Access Compliance Report

Public Rights-of-Way

| Intersection ID: 25356 | Main Street: PLANTERS_KNOB_LN | Cross Street: ROCKY_TRACE_WY | Location: NW |
| ADA ID: 023CC47B73EF | Ramp Type: PerpDiag | Initial Pass/Fail: Fail | Overall Compliance: No |

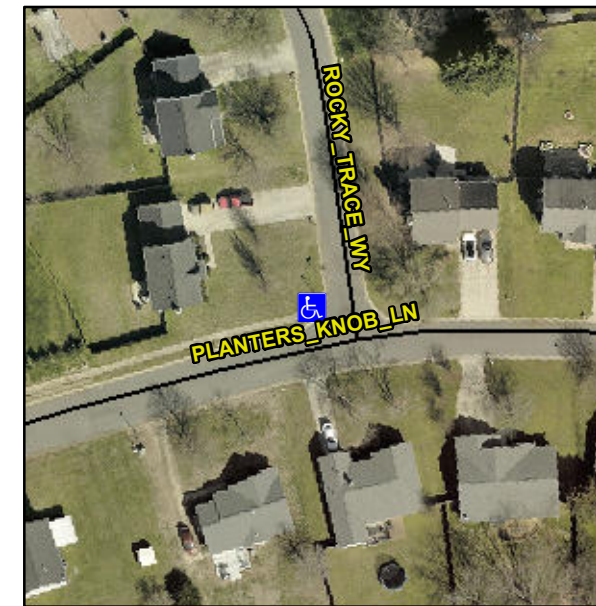
Not Found, R304.2.2, R304.5.3

| Compliance | Description | Data | Compliance | Description | Data |
|------------|-----------------------|------|------------|-----------------------------|------|
| N/A | Ramp Length (in) | 51.0 | No | Ramp Slope (%) | 10.8 |
| Yes | Ramp Width (in) | 48.0 | No | Ramp XSlope (%) | 3.4 |

Remove & Replace Curb Ramp With Two New Directional Ramps or Equivalent.
